## Technical Note

Project: Ryebank Fields, Chorlton

Title: Layout Update – Highways Aspects

**Figure 2.1:** Driveway & Parking Bay Positions – Submitted Layout

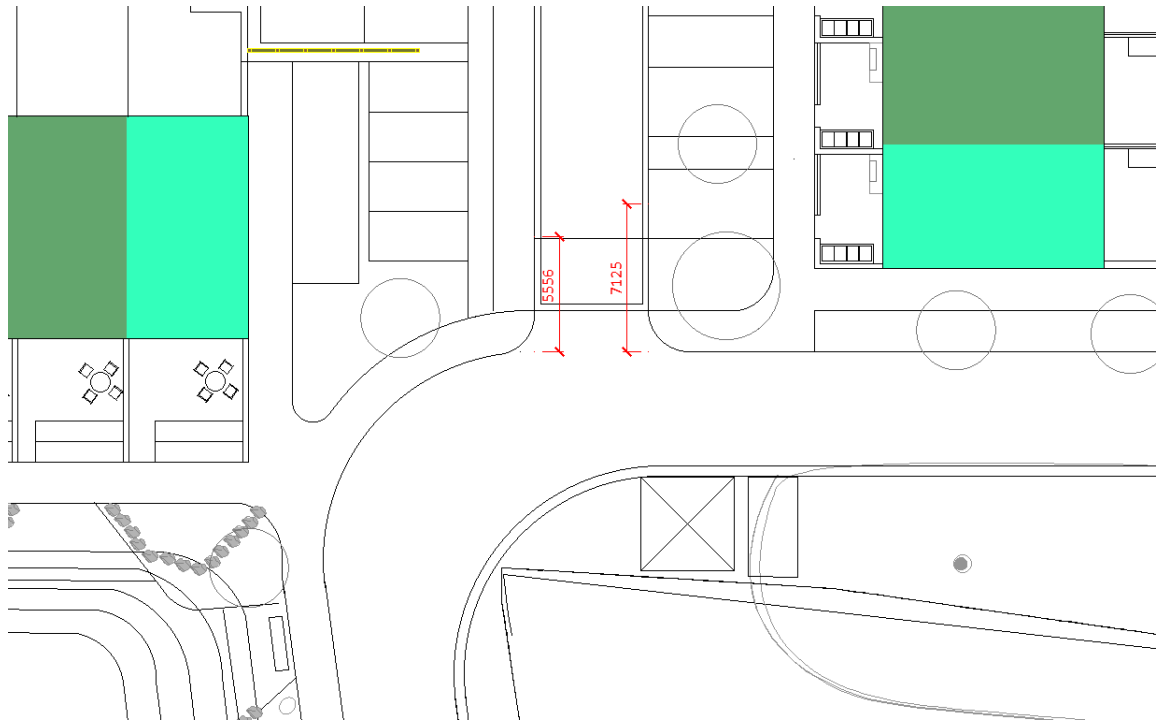
- 2.4 As a consequence of the road realignment, the arrangement of the internal junction has been updated and parking bays in the immediate vicinity are proposed to be reconfigured. This area had previously been subject of detailed discussion relating to the proximity of the parking bays/driveways to the junction, including a specific review within the Stage 1 Road Safety Audit (RSA). This was prompted as Manchester City Council has a normal separation requirement of 10m a junction for driveways/parking spaces.
- 2.5 The submitted layout had a driveway positioned 7.1m from the internal junction (east side) and a row of parking bays on the western side, the first of which was positioned 5.6m from the junction, as shown in Figure 2.1 below.

- 2.8 The amended layout takes the parking bays into a separate parking court, such that none of these spaces are within 10m of the junction. The reconfigured driveway arrangement on the eastern side also increases the separation distance to the first driveway, to over 9m as shown above. These changes are therefore beneficial in both cases, in terms of the spacing issue.

### 1. Road moves North to pavement line.

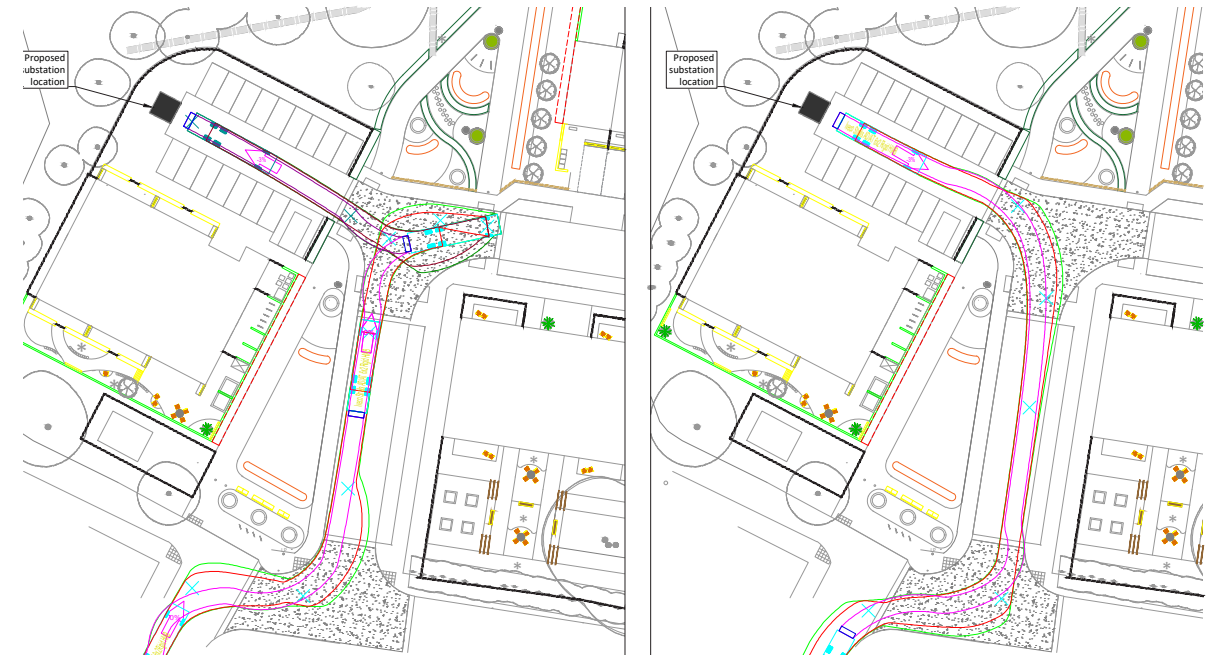
Loss of raingardens and relocation of new trees within the masterplan. Better layout for RPA of buffer trees.

### 2. Relocate Substation to co-ordinate with road realignment.

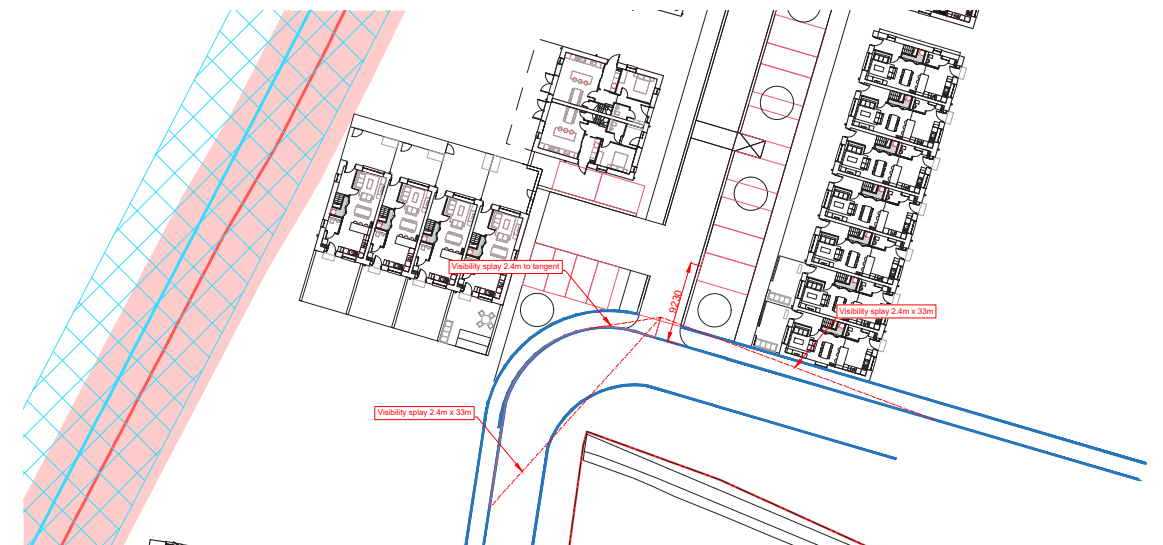
Better location to LV supply from Longford Road

### 3. New car parking/ bins/ cycle arrangement

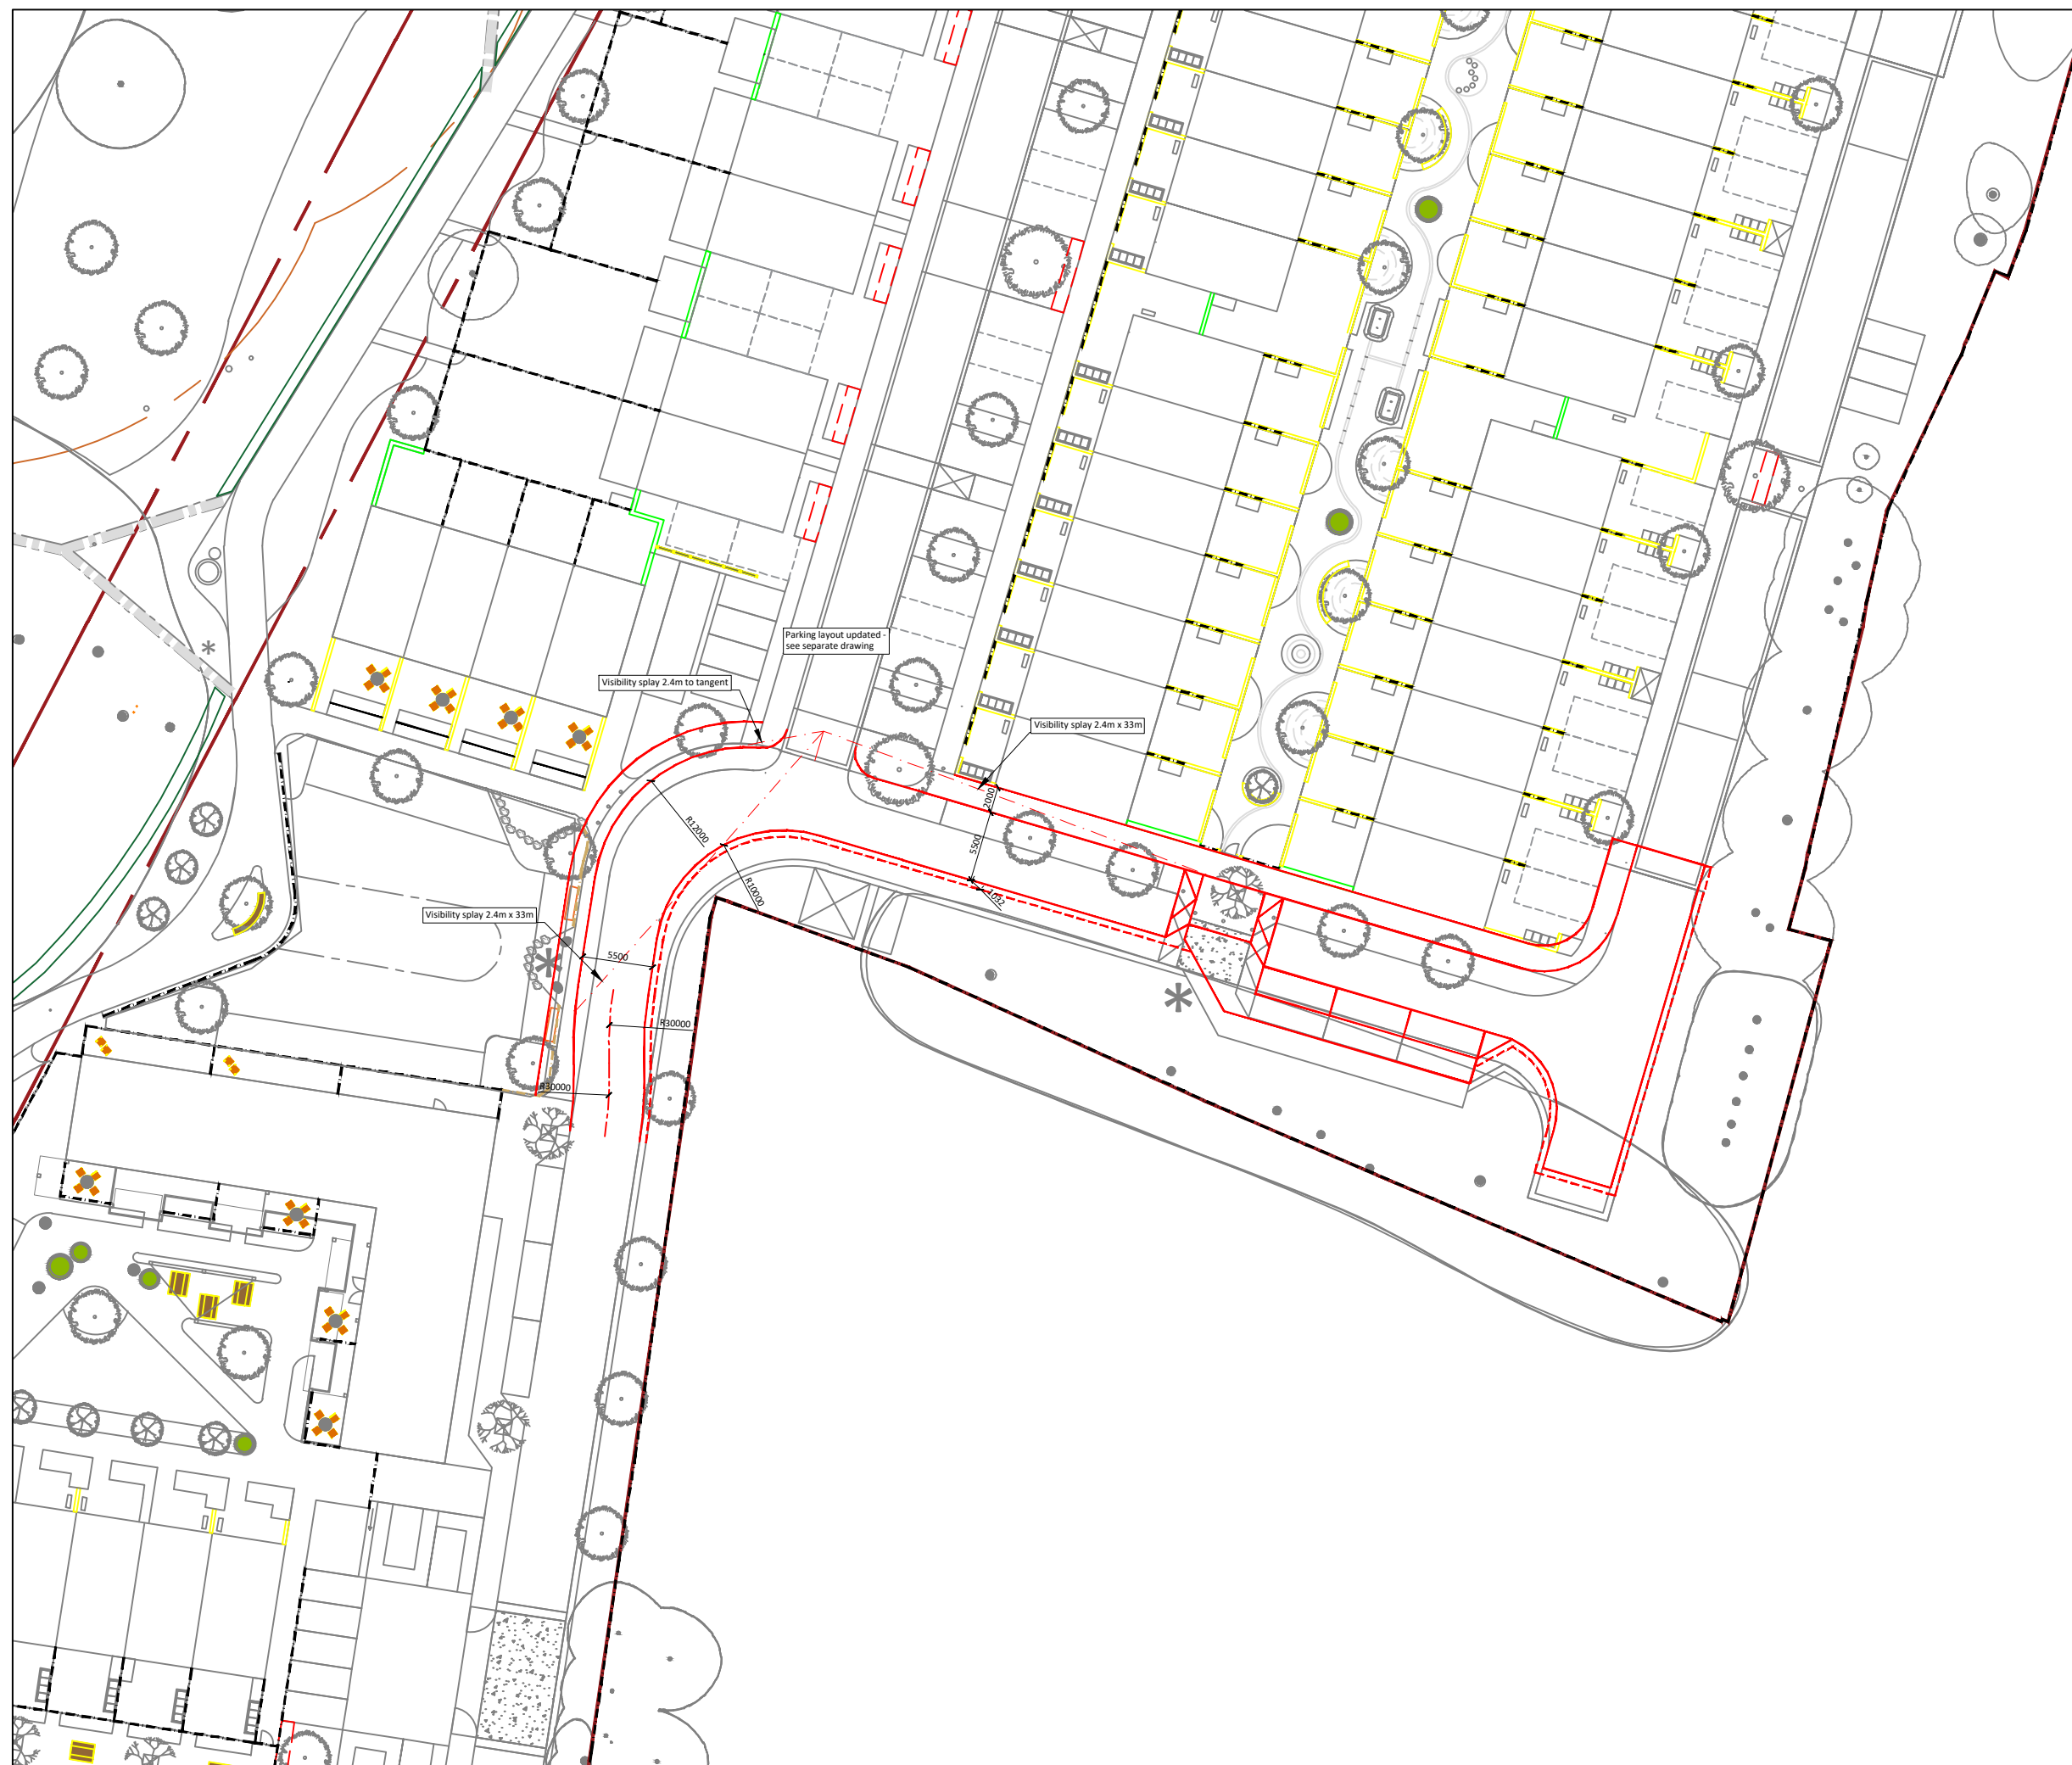
Better distances between driveways and junction (9m vs 5.5/7m)  
Car parking rearranged. Bin and Bike strategy reconfigured.

### Proposed Internal Road Layout Changes

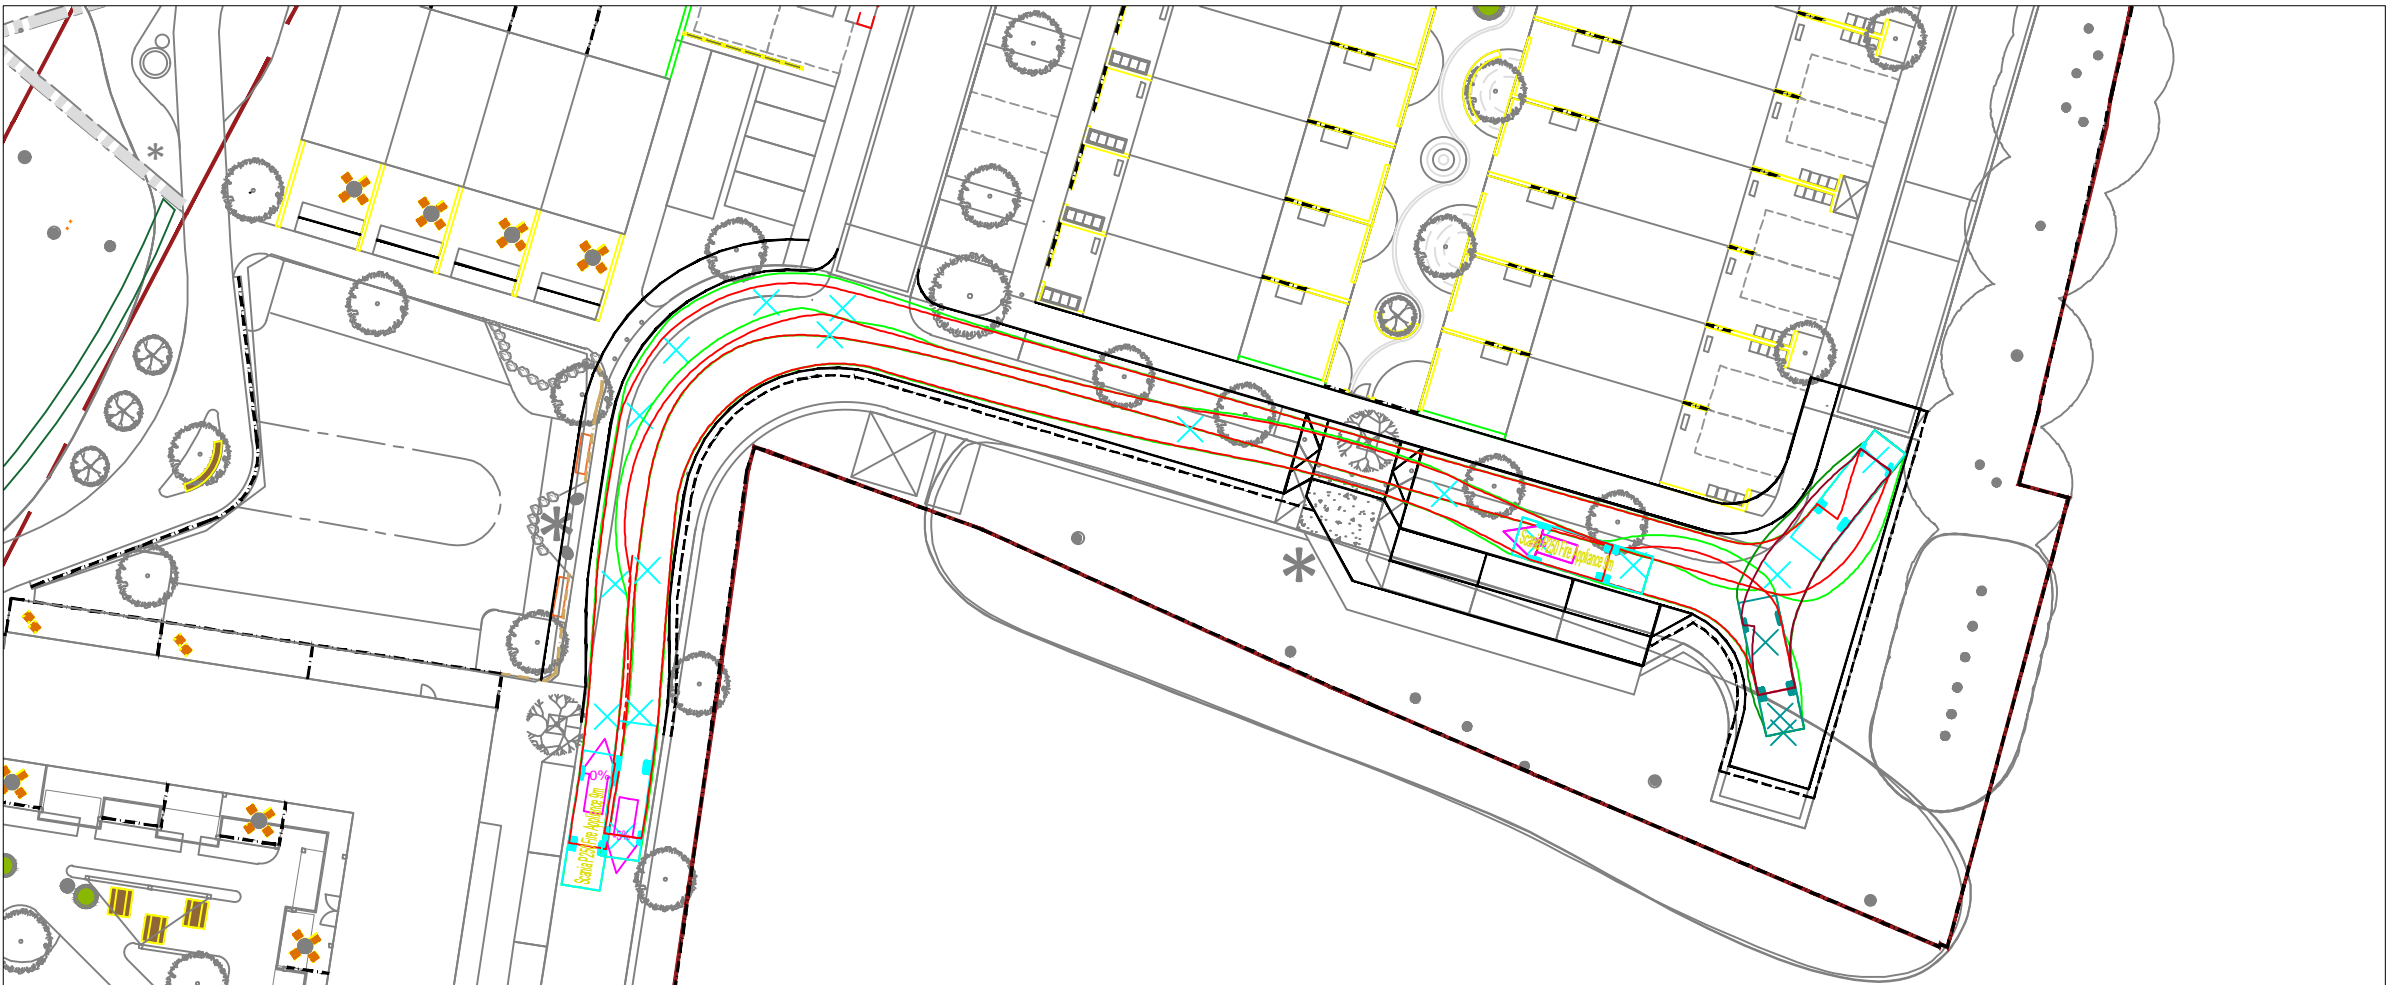
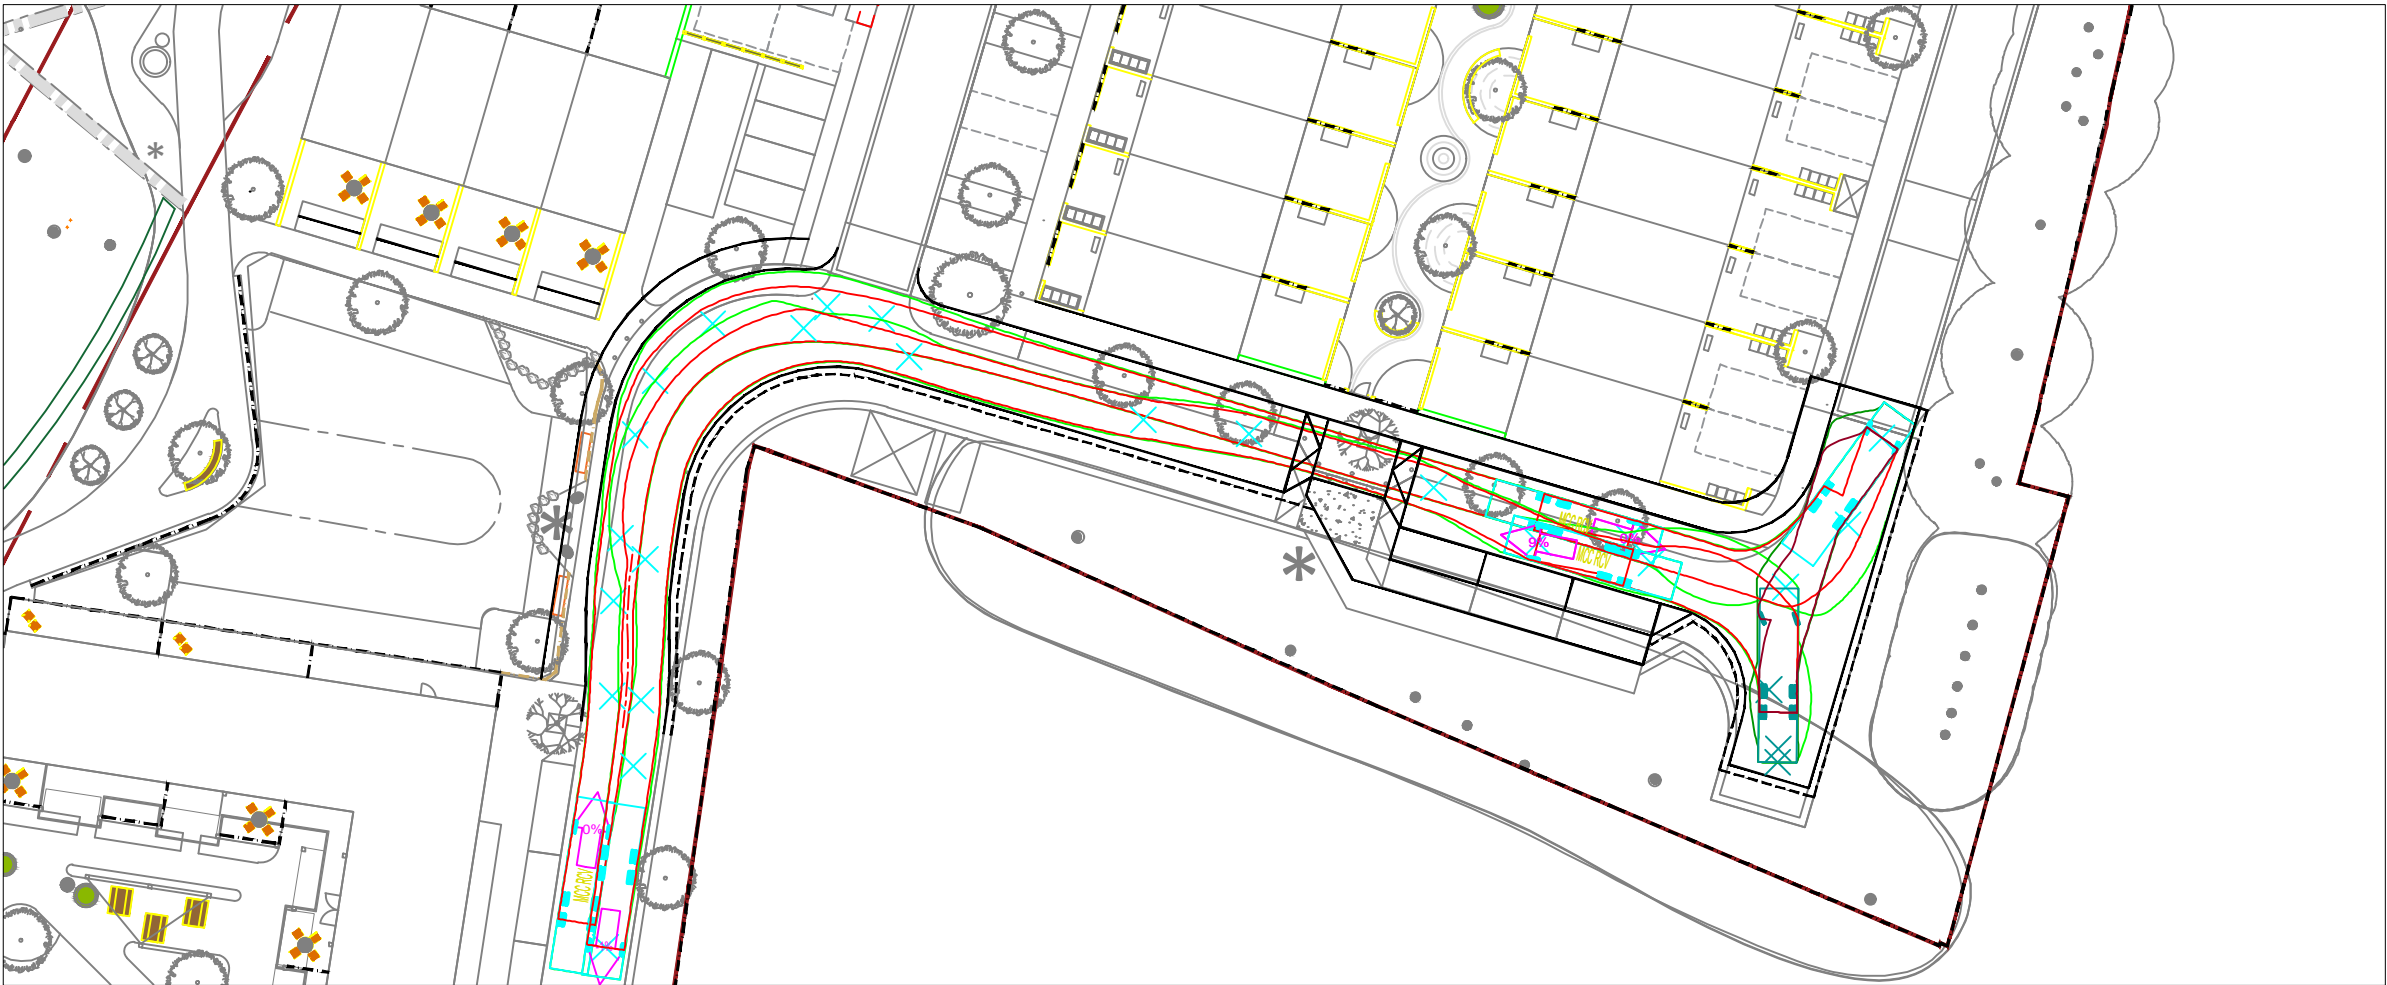
- 2.1 The change in alignment of the internal spine road within the southern portion of the site has been necessitated by drainage and flood risk requirements. The change essentially maintains the former road geometry at the bend and through to the turning head, but with the separation increased between the road and the site boundary.
- 2.2 A transition section is introduced to achieve the realignment. The proposed layout is shown overlaid on the previous layout in Appendix B, along with key geometric parameters. The carriageway is widened through the bend, as in the previous layout.
- 2.3 As indicated above, updated swept path analysis has been undertaken for service and emergency vehicle types. These are presented in Appendix C and demonstrate that the change will not adversely impact accessibility for large vehicle types.

Proposed amendments to road layout shown red
